ADDENDUM NUMBER 06

NEW LEGISLATIVE PARKING GARAGE

DIVISION OF PUBLIC WORKS PROJECT NUMBER 81284

May 16, 2024

CHANGES TO THE DRAWINGS

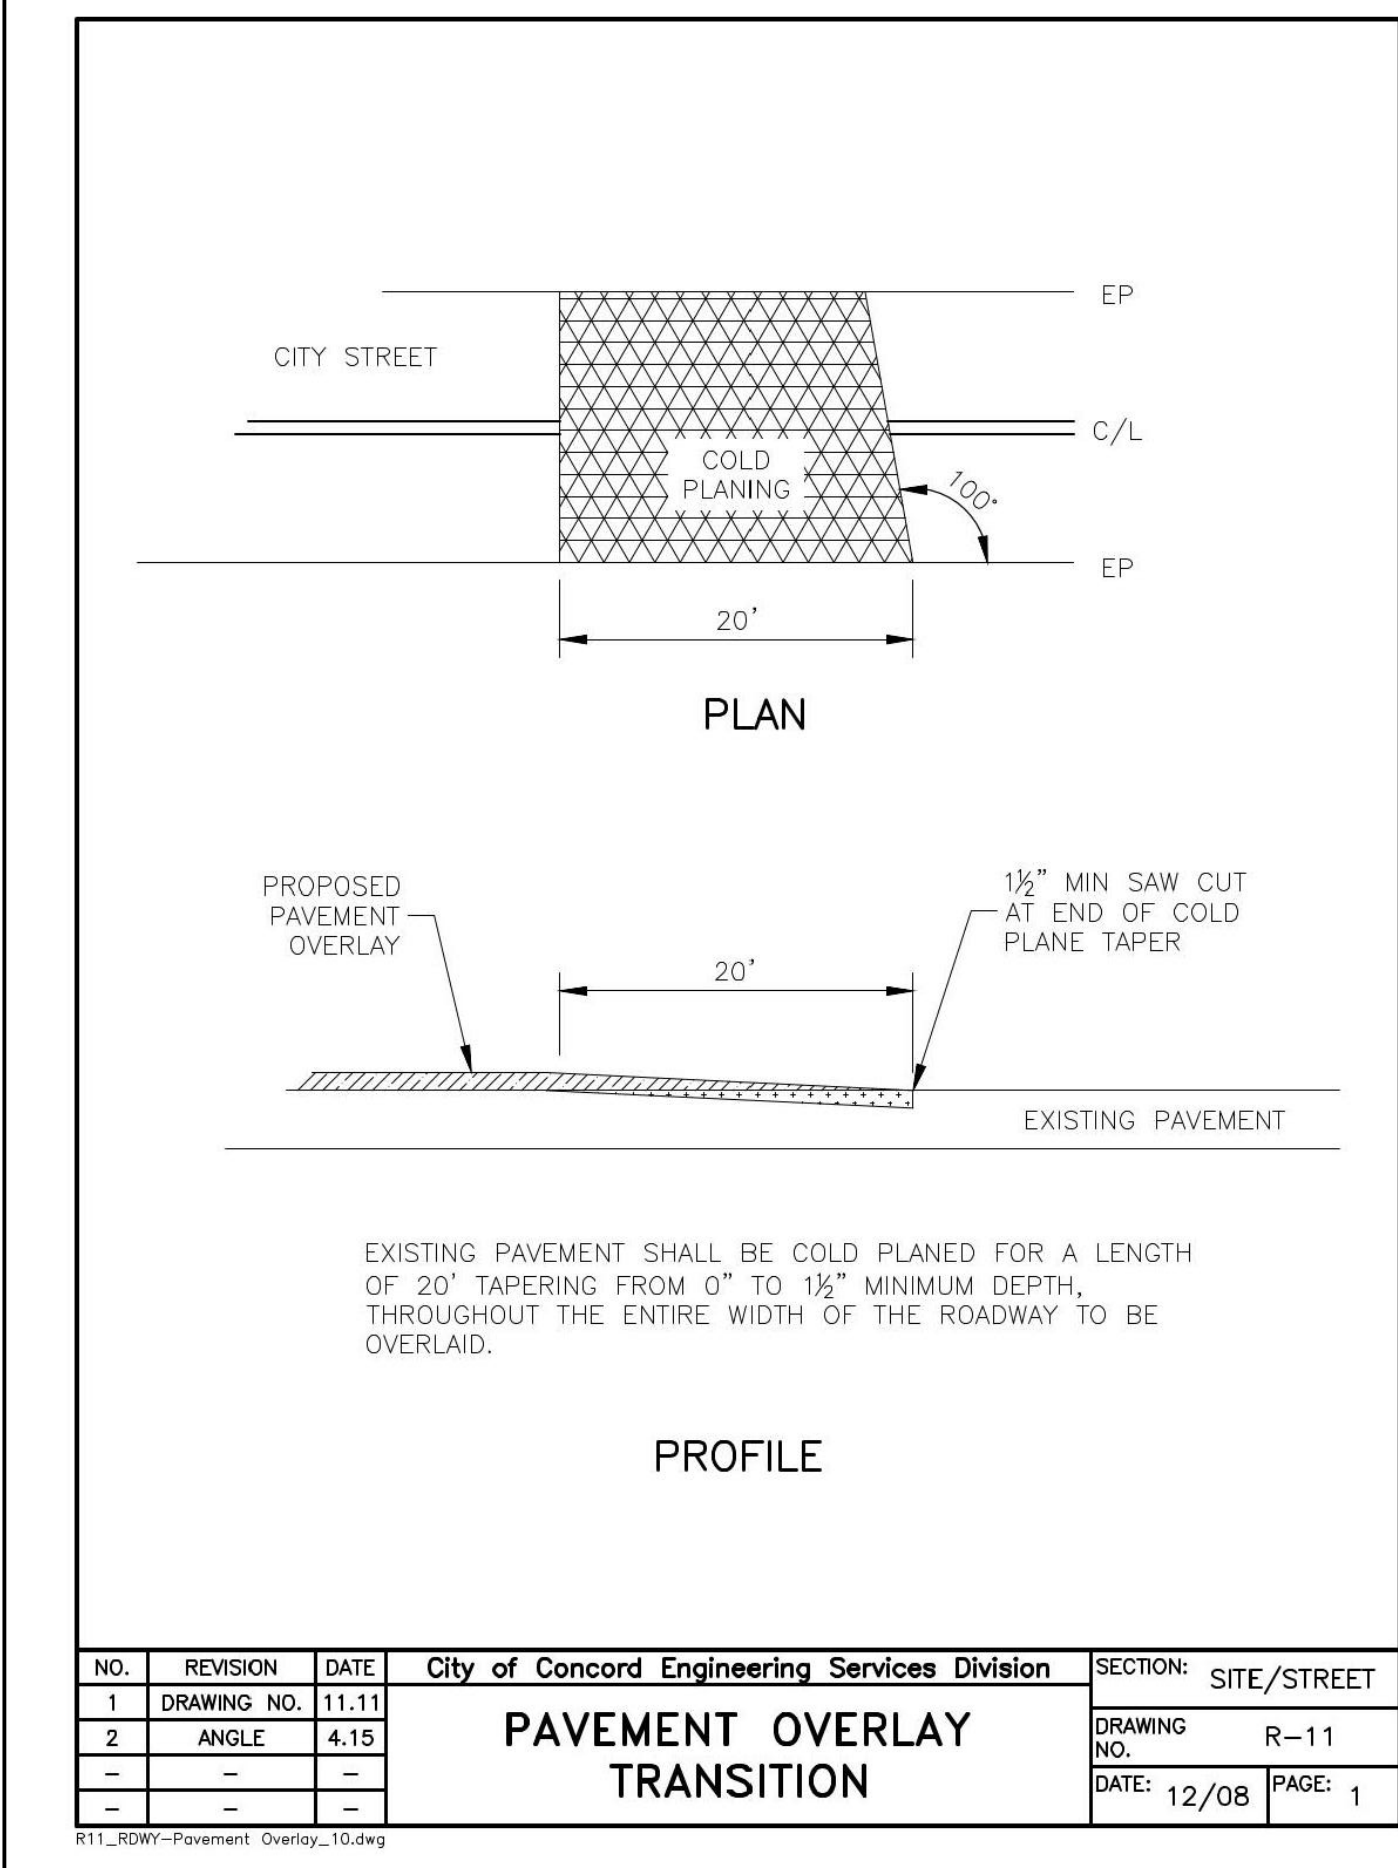
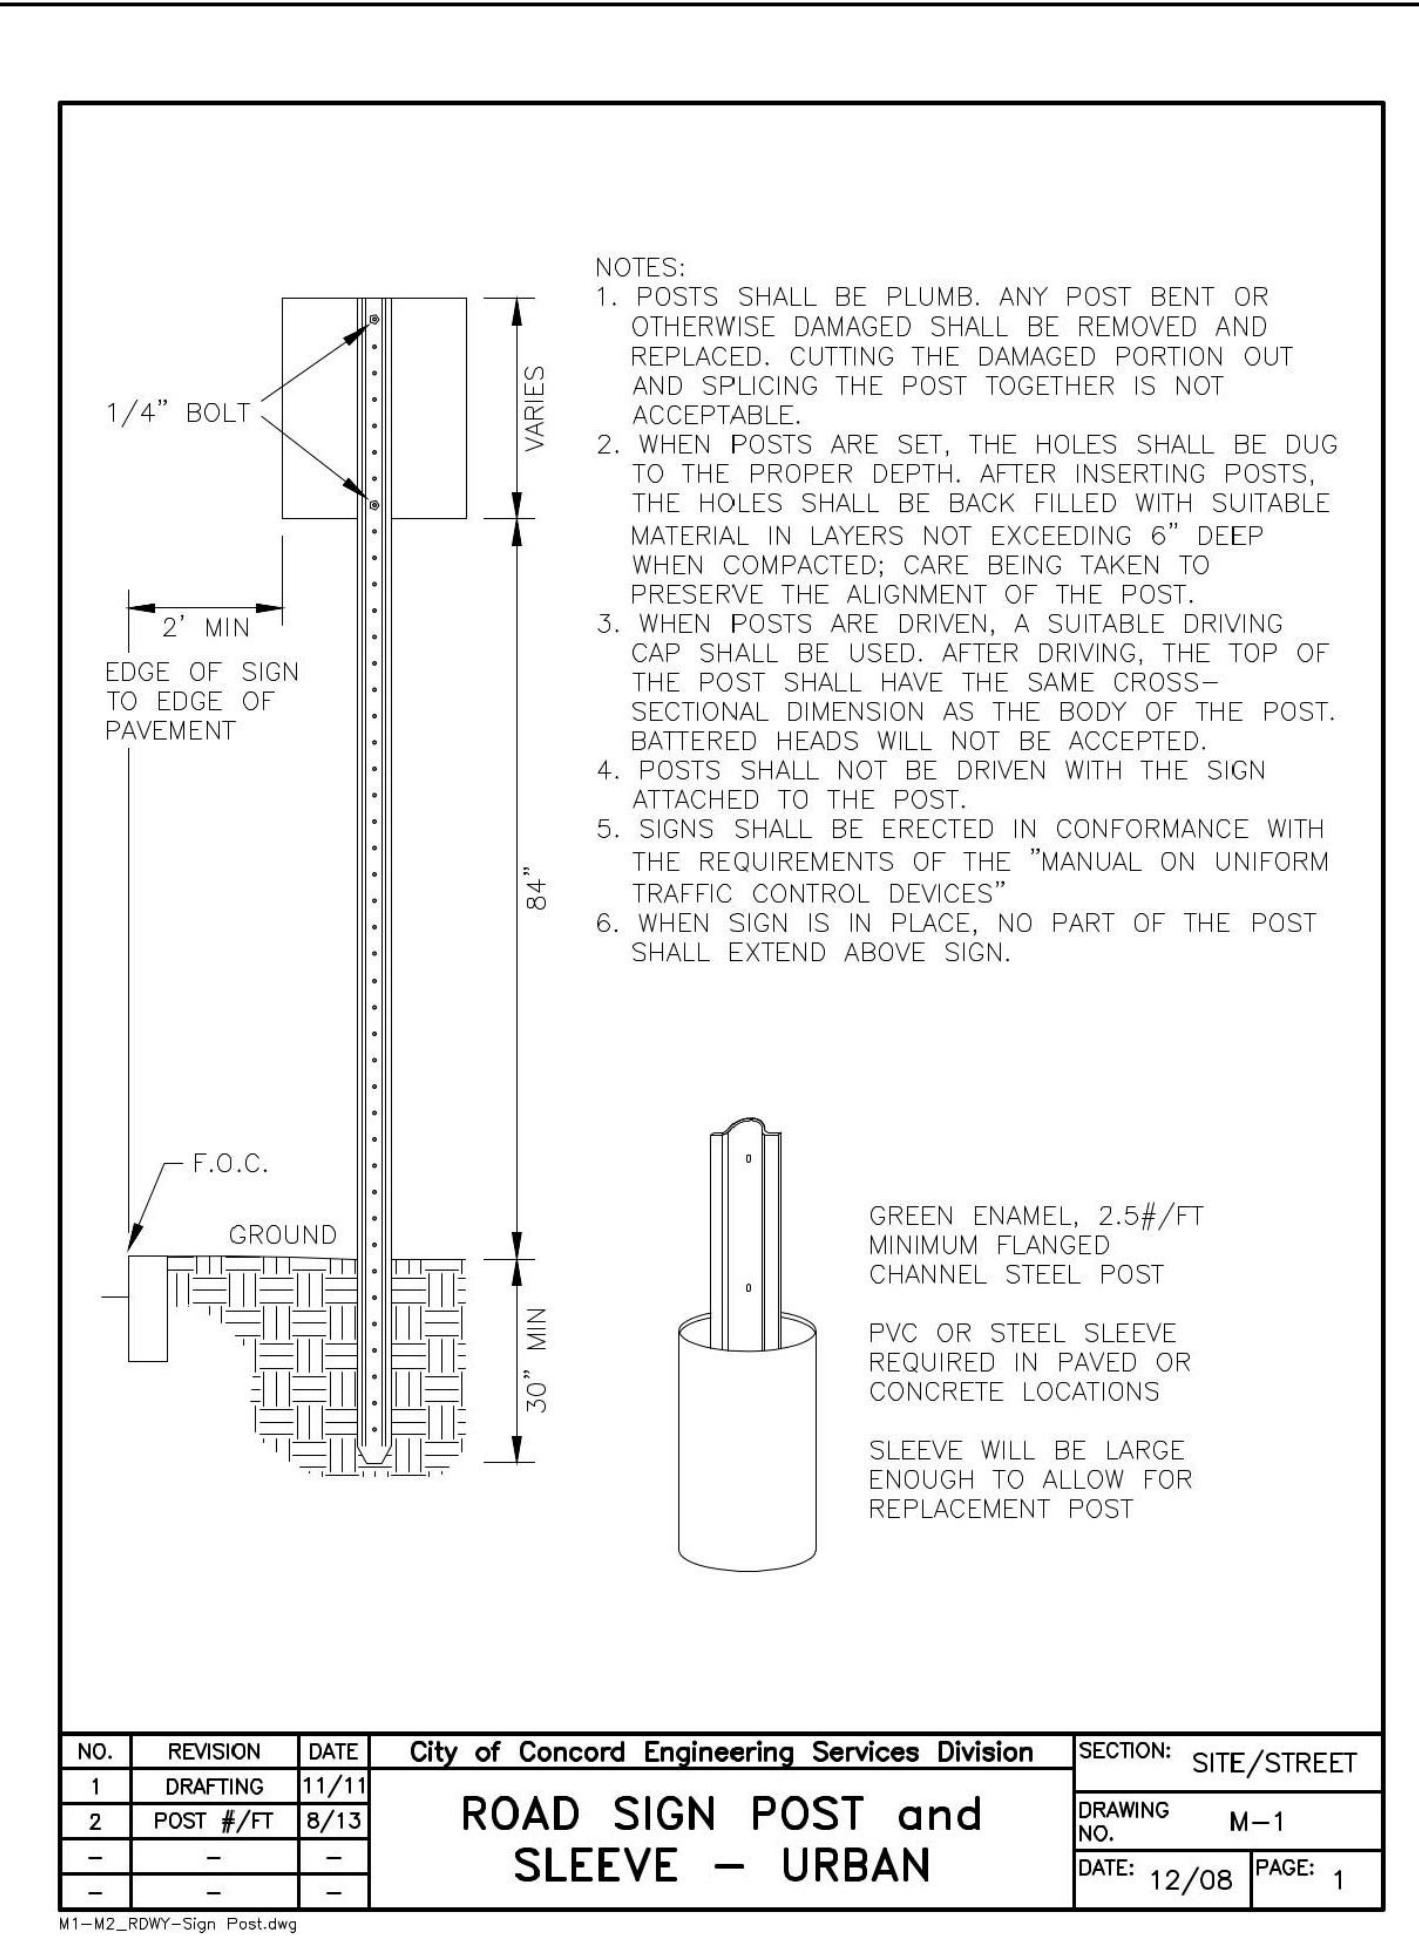
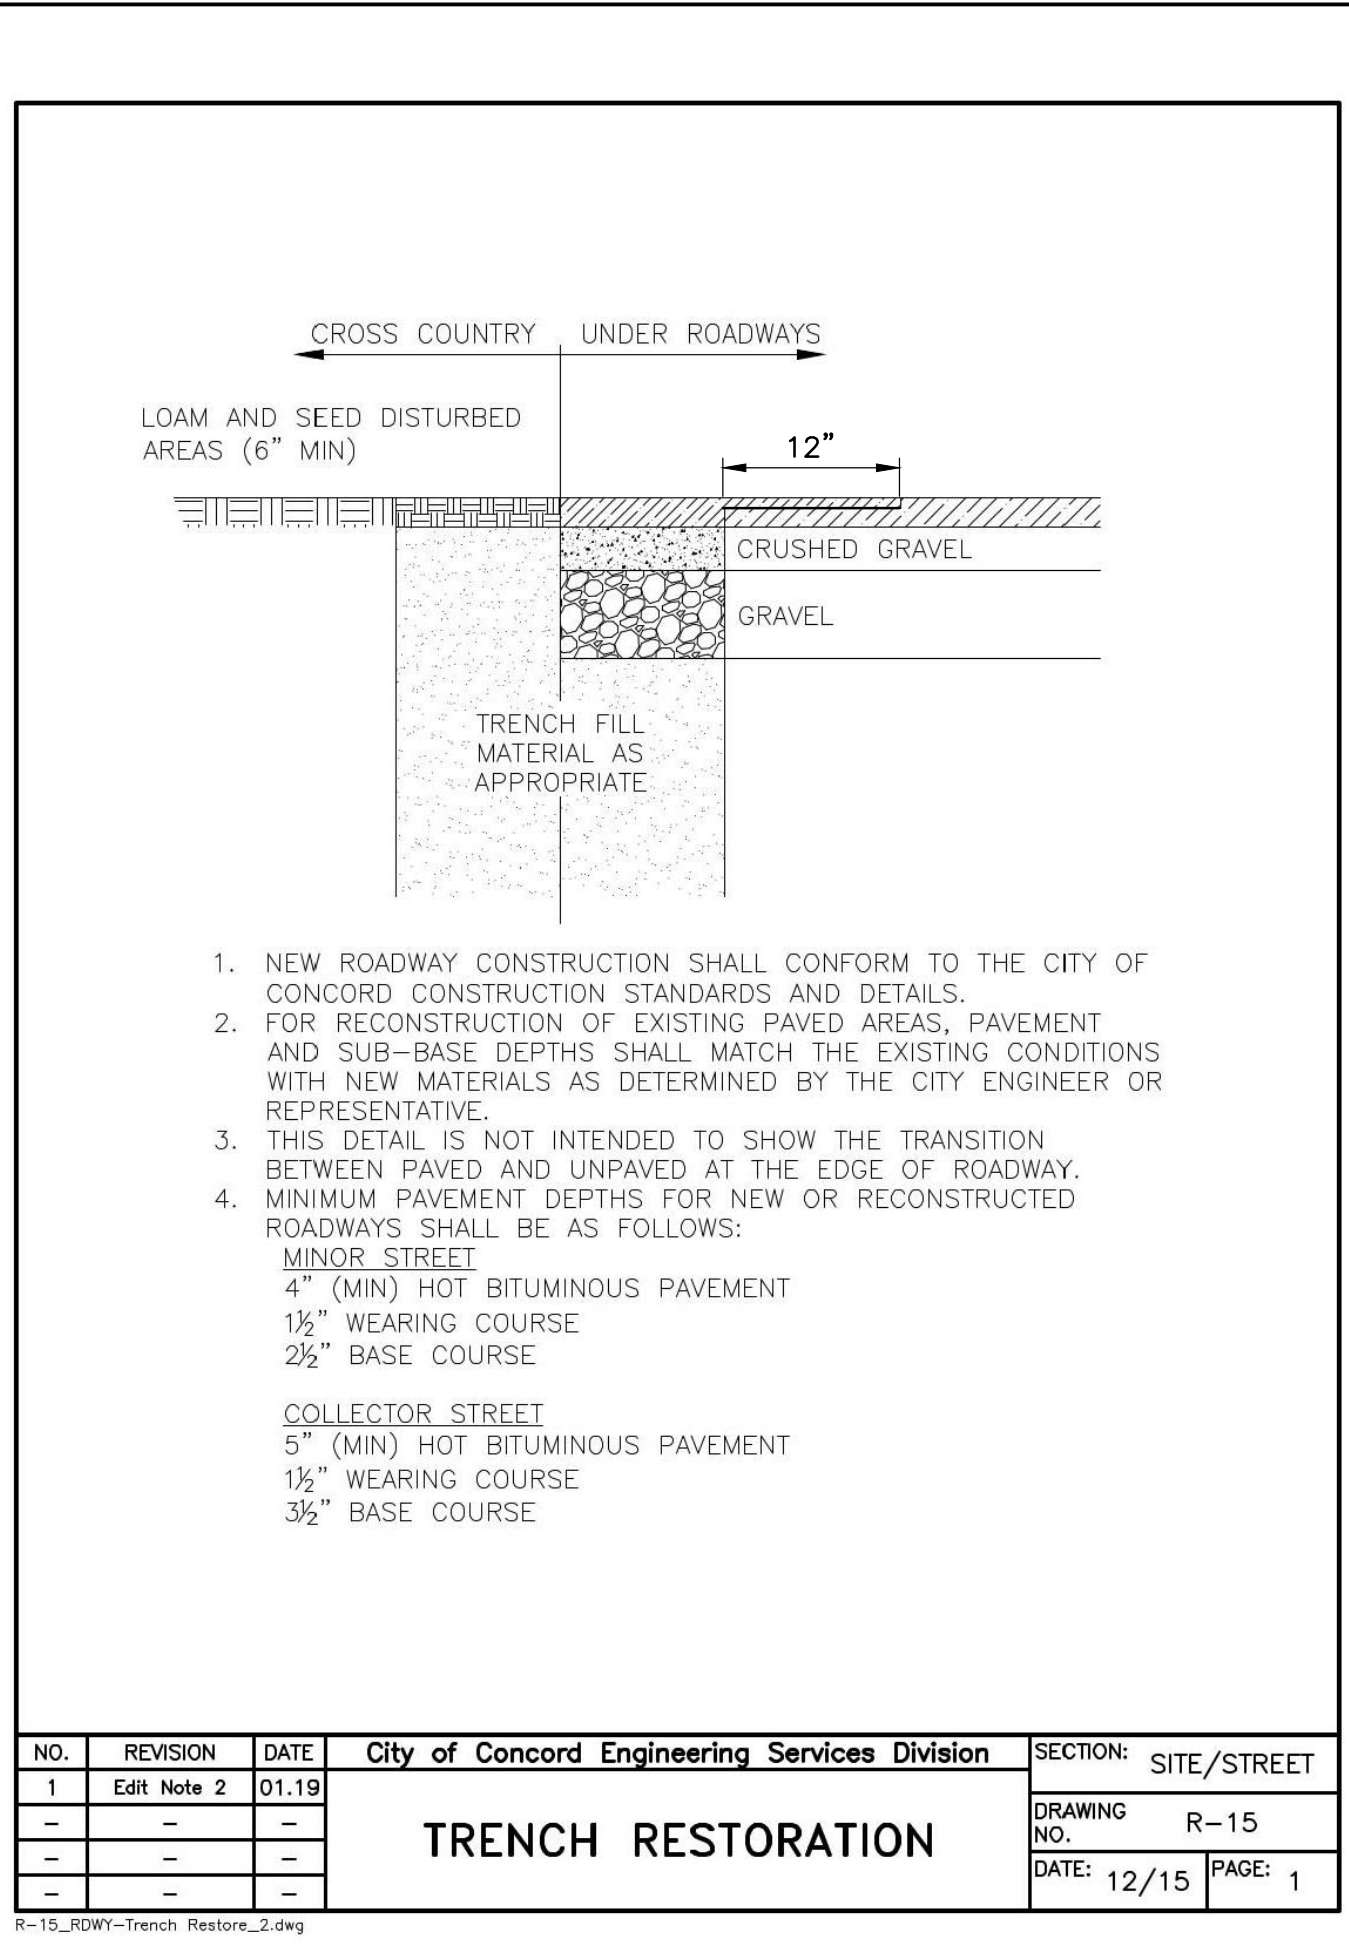
2. Q: The roadway paving detail 1/C5.01 indicates the final wearing course is to be paved by others. Is this the case? If this is the case, are structures within these areas be left 1.5” above grade? For the bid alternate, will this final paving course be by others according to 1/C5.01?

3. Q: In reference to Q&A #1 on Addendum #3 regarding parking garage asphalt thickness, the city street asphalt section is called out to be 5.5” thick of asphalt. Please confirm that 5.5” of asphalt is to be

placed on 1st floor of parking garage. In the detail, it also references top coat to be by others so where does that come in to play with the garage asphalt?

A. Street paving final wear course will be by others: Depending upon construction sequencing, the contractor shall either install the rim elevations to finished grade elevation (as they are currently shown within the plan set), or shall install the rims 1.5" below finished grade. Contractor to coordinate with the City of Concord to determine this elevation, but shall provide the flexibility for all proposed structures to be raised or lowered by utilizing a minimum of (2) courses of brick, and a maximum of (5) courses of brick per the City of Concord Standard Details.

B. Paving within the garage (bid alternate): No paving within the garage for the bid alternate will be performed "by others." Please see the revised Sheet C5.01.

A. Yes, 5.5” of asphalt is called for in the bid alternate for pavement in the garage. Please see response to question 2 above and reference revised sheet C5.01.
